RE: PB 20-15 (Aug 4, 2021 Submission) - PJ Train Station Redevelopment

Princeton Junction Train Station Redevelopment

Landscape Architectural Review Report

Preliminary and Final Major Site Plan Township Planning Board Memorandum #1 West Windsor Township Application PB 20-15

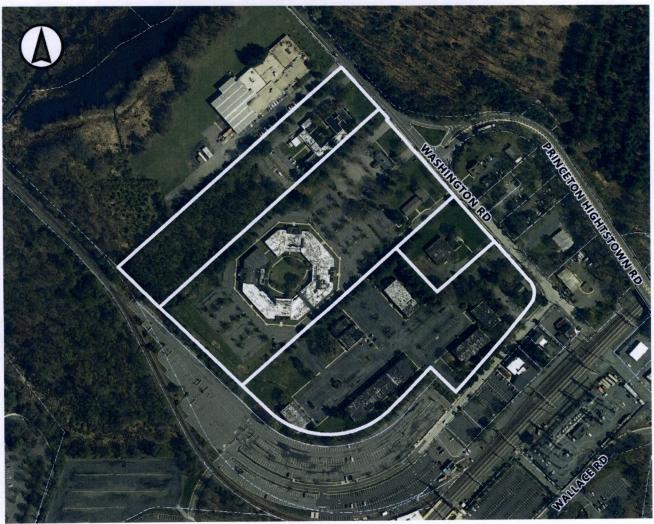
- a. <u>Parking Management</u>. The applicant has provided a parking plan. Testimony should be provided as to how parking will be managed and assigned for tenants. We note that the applicant has identified the location of reserved parking spaces for affordable units. Testimony should be provided as to whether these spaces will be reserved with signage, markings, tags, or a combination thereof.
- b. <u>Electric Vehicle (EV) Parking</u>. The applicant has proposed fifty (50) EV parking spaces in Parking Garage East and thirty-six (36) EV parking spaces in Parking Garage West. Four (4) of the ADA spaces will feature EV charging. We recommend the applicant install internal signage into the garage indicating the location of these ADA EV spaces.
